15 June 2021

**Nature Conservation Council Objection to DA183/1993.2 / 5.1993.183.2 at 112 Long Point – West Road, WARKWORTH Lot 450 DP 1119428 for S4.56 Modification to allow use of biomass as a fuel source**

(Fig. 3: The chart above is derived from data from various sources for units burning biomass for fuel, assembled by Mary S Booth, Partnership for Policy Integrity [www.pfpi.net](http://www.pfpi.net))

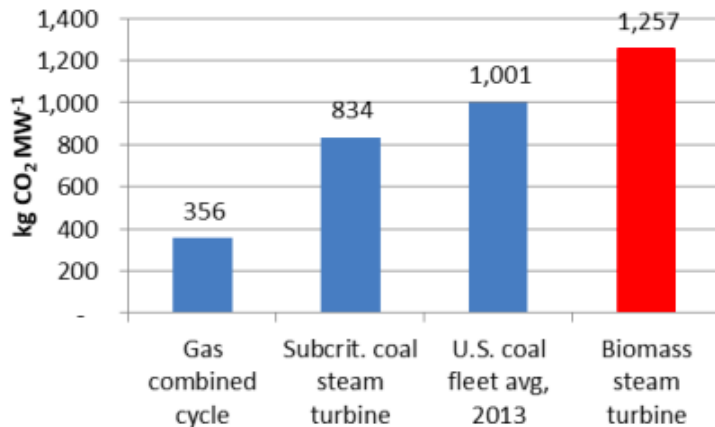
Wood biomass can actually emit up to 50 percent more CO<sub>2</sub> than coal when burnt, yet carbon accounting used by the proponent classes it as zero carbon, because trees absorb CO<sub>2</sub> when they grow.<sup>xviii</sup> This is reflected in the proponent's SEE (Figure 2 below).

Burning native forest biomass produces more greenhouse emissions than burning coal at the point of combustion. It is incorrect to use accounting methods that claim that recapture of greenhouse gasses by regrowing forests over decades can offset these emissions within the timeframe available to vastly reduce emissions to avoid catastrophic global warming.
